## Replacing SAC design clutch with conventional aftermarket replacement.

## Dual mass flywheel identification on Mercedes Sprinter

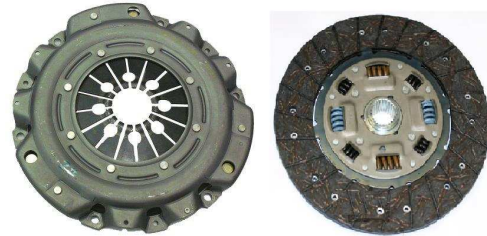
The enclosed parts differ in appearance to the original equipment design.

### Original clutch design

### Aftermarket clutch design

We have carried out stringent testing and evaluation to ensure the units are suitable alternatives.
